CALIFORNIA COASTAL COMMISSION

**STAFF REPORT: REVISED FINDINGS****APPLICATION NUMBER: 4-97-123****APPLICANT:** Soka University of America **AGENTS:** M. Andriette Culbertson, David Neish**PROJECT LOCATION:** 26800 Mulholland Highway, Malibu, Los Angeles County**COMMISSION ACTION:** Approval with Modifications**DATE OF COMMISSION ACTION:** April 9, 1998**COMMISSIONERS ON THE PREVAILING SIDE:** Allen, Brothers, Dettloff, Flemming, Kehoe, Reilly, Staffel, Tuttle, and Chairman Areias

SHEET NO 4 OF 4	DATE 2/19/98	SHEET TITLE BUILDING REVISED 22 & 23		SUMMIT ARCHITECTS, INC. 520 Broadway, Suite 450 Santa Monica, CA 90401 (310) 393-8571 Fax (310) 393-9124
	JOB NO 3001			
	DRAWN SB			
	APPROVED

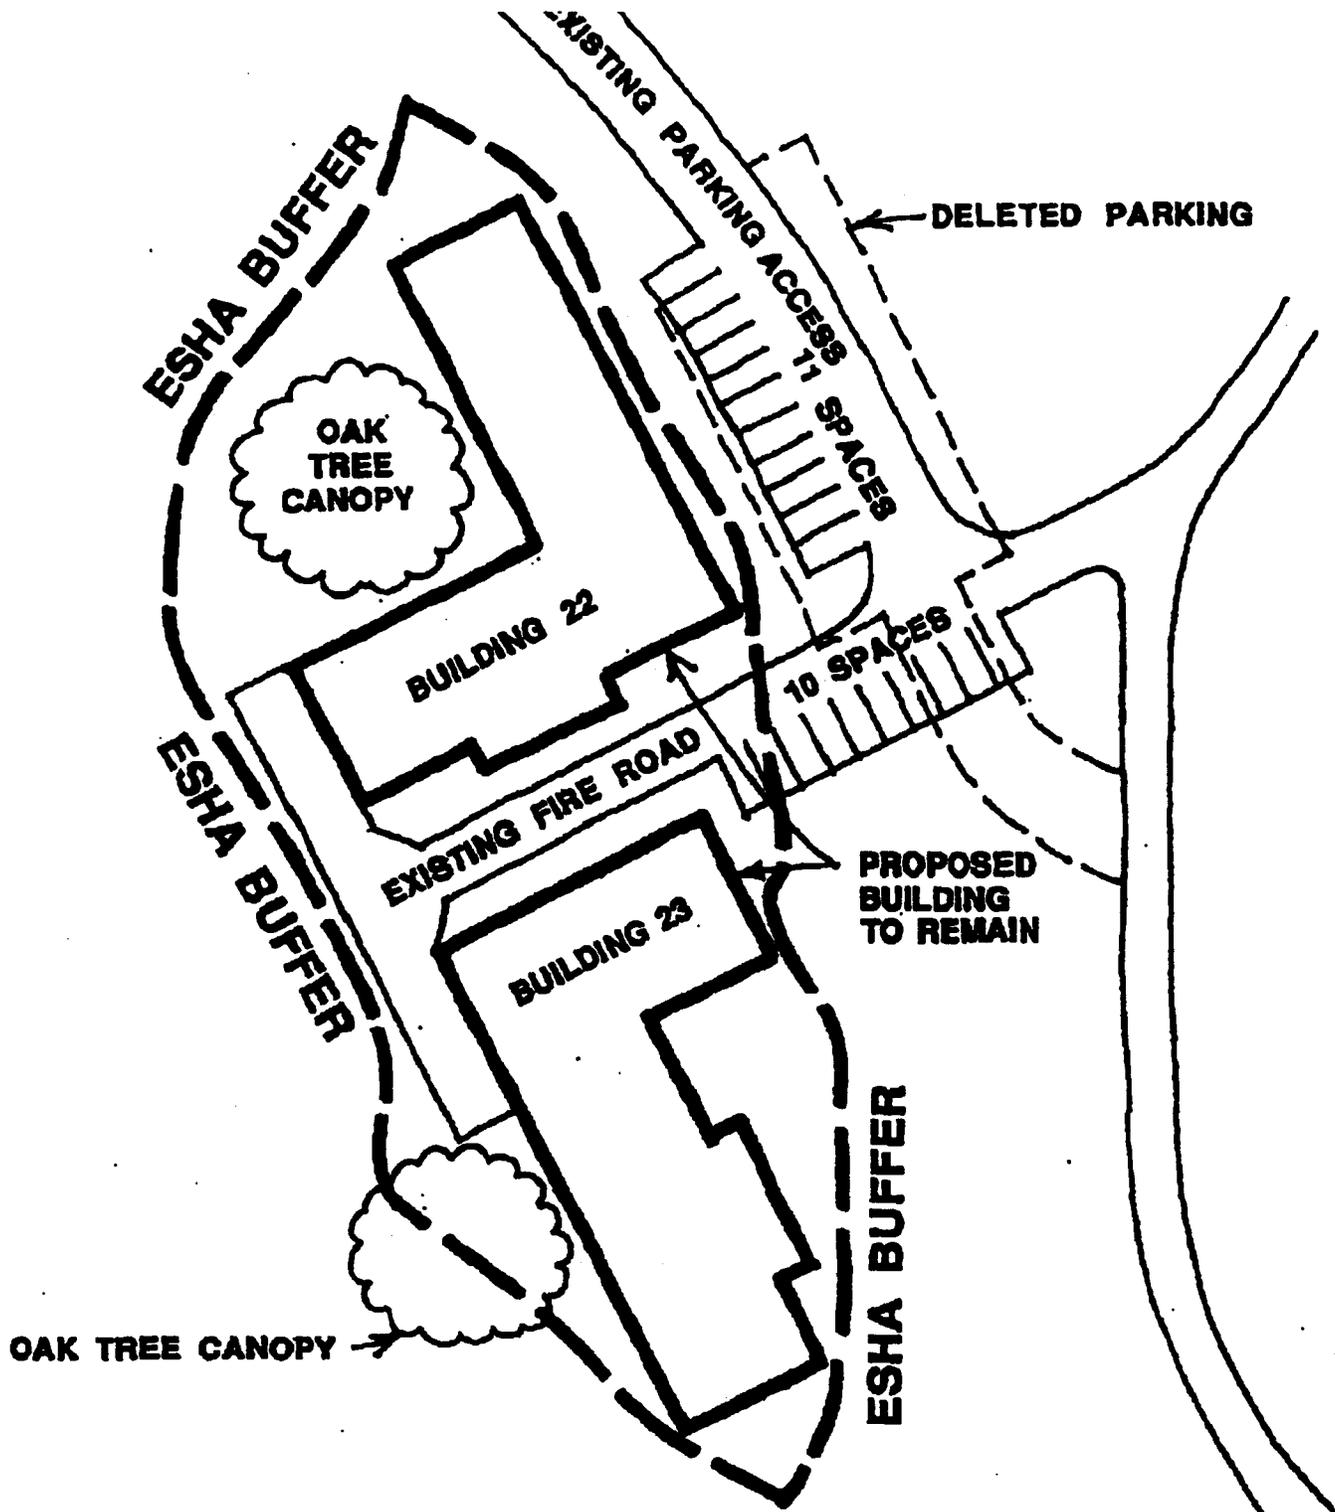
The road proposed to provide access to dormitory Buildings 22 and 23 would pass through the area within the 100-foot setback from oak woodland ESHAs, although the buildings themselves would be located outside the 100-foot setback area. Condition No. 2 requires that the proposed road be redesigned to avoid a Significant Oak Woodland area to the north side of the road. The proposed Buildings 22 and 23 would both be located on a flat area rising on three sides to hillsides covered in oak woodland ESHAs.

Staff explored alternative locations for the proposed road and parking. Exhibit 23 shows an alternative configuration for the proposed parking which would result in two parking areas directly off the proposed road, providing a greater setback from the ESHA to the east. The road would remain in the same proposed location. Given the configuration of this area of the site and the position of ESHAs on three sides, it would not be possible to provide road access or parking for these proposed structures which is set back 100 feet or more from each ESHA. Although the alternative shown in Exhibit 23 does provide a greater setback from ESHAs, it does not provide a 100-foot setback. A different alternative evaluated by staff involves the redesign of the parking area for Buildings 22 and 23 so that only handicapped parking (the applicant estimates that approximately four spaces would be necessary for these two buildings) and a drop-off or loading and emergency access zone would be provided adjacent to these two buildings. Long-term parking could be provided in the main campus area and students could walk or bicycle to Buildings 22 and 23. Removing any long-term parking (with the exception of handicapped parking) would maximize the setback from the ESHA, maximize the area available for oak tree recruitment, minimize the amount of impermeable paving, reduce the presence of vehicles in this area, to provide additional protection for the ESHAs. Condition No. 2e requires that the proposed plan be revised to incorporate this modification to the parking lot for Buildings 22 and 23.

Based on staff's review of the proposed project, the review of the applicant's consulting biologist, and the review of the Commission's staff biologist, the proposed road and parking for Buildings 22 and 23, as conditioned to redesign the parking and to use permeable paving on the road, as well as the proposed debris basins, all of which would encroach into the 100-foot ESHA setback, will not significantly degrade the nearby oak woodland ESHAs. Furthermore, as conditioned to submit a detailed fuel modification plan, fuel modification activities will not significantly degrade the habitat values of the oak woodland ESHA. The proposed development would be sited and designed to prevent impacts which would significantly degrade the ESHAs, as required by Section 30240 of the Coastal Act. There is no feasible alternative road configuration to Buildings 22 and 23 which could be located outside the 100-foot ESHA setback. Utilizing the existing, paved, 12-15 foot wide road to provide access to Buildings 22 and 23 would result in significant landform alteration and impacts to oak trees within an oak woodland ESHA.
